Appl. No. 10/770,926  
Amdt. dated October 25, 2005  
Reply to Office Action of July 26, 2005

Amendments to the Drawings:

FIG. 2

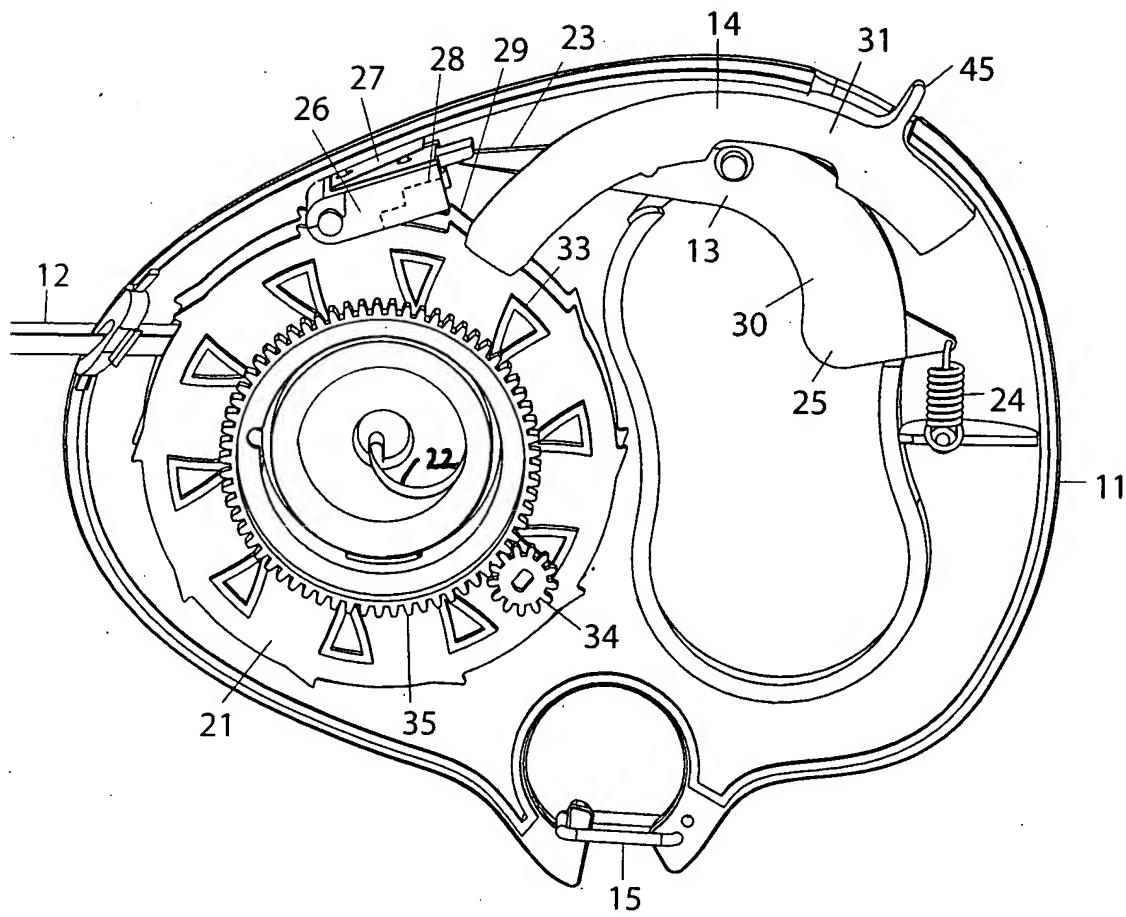
As required by the Official Action, included in the amendment are an "Annotated Sheet Showing Changes" and a "Replacement Sheet" for Fig. 2. In Fig. 2 the reference numeral "22" has been added for the spring which biases reel 21 as described at page 5, line 17 of the specification.
